**GOVERNMENT OF THE DISTRICT OF COLUMBIA
DEPARTMENT OF TRANSPORTATION**

MEMORANDUM

DATE: May 30, 2017

SUBJECT: ZC Case No. 16-18A –Medstar Georgetown University Hospital Surgical Pavilion

Figure 1: Site Circulation (Source: Applicant)

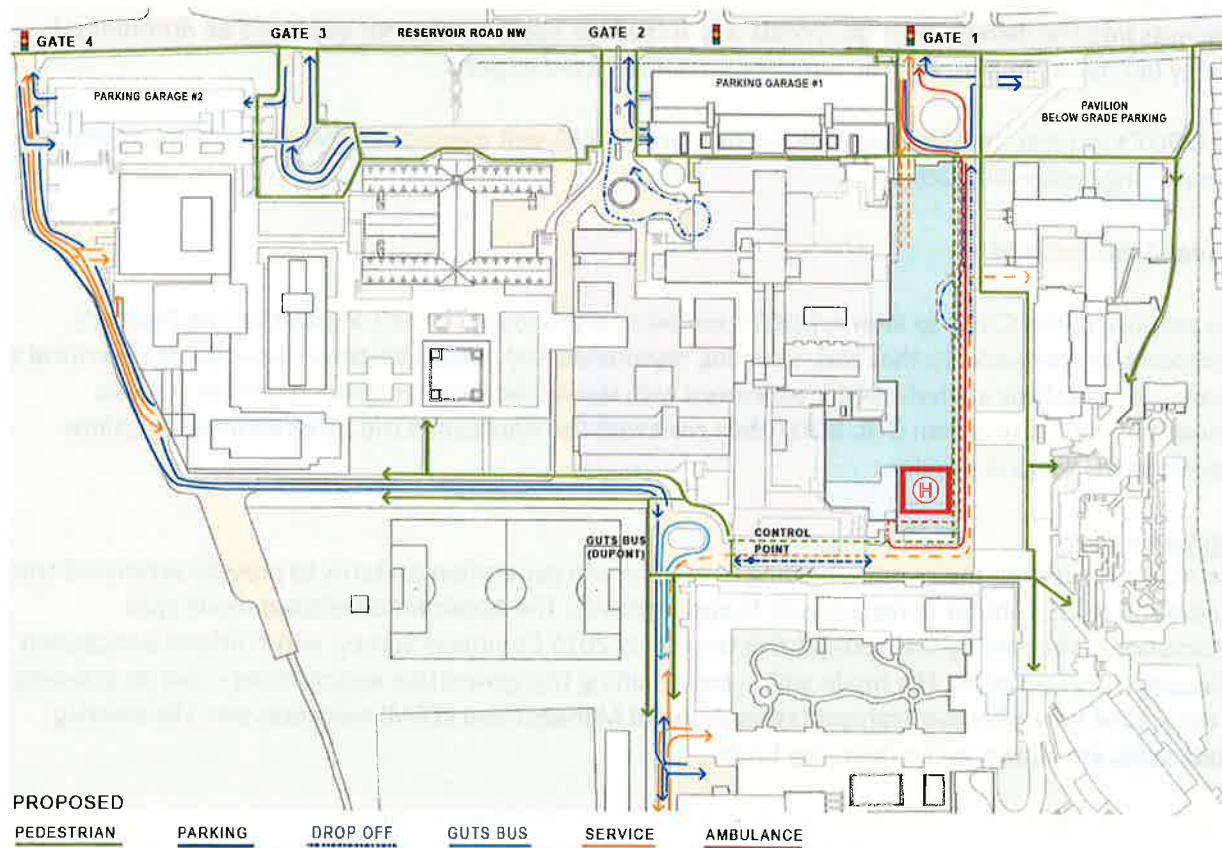
Two main access points are being changed to meet hospital needs and accommodate the surrounding residential neighborhoods. First, at Gate 1, the entrance is being proposed to shift slightly to the west. This will improve existing conditions, and will allow improved operations at this intersection. Access to the new surgical pavilion will be via the modified Gate 1 entrance. Second, an improved Gate 4 access is proposed to provide added connection to the proposed east-west roadway within the campus. This new east-west roadway connects Gate 4 to the north-south campus roadways at the rear of the hospital facilities. New traffic signals are proposed at both locations (one signal at the Gate 1 location to replace/modify the existing signal, and one new signal at the Gate 4 location). To further facilitate internal circulation, new traffic control gates will be installed to channelize vehicular traffic to improve non-auto campus conditions and more effectively manage vehicles on campus. Please reference Figure 1 for proposed site circulation.
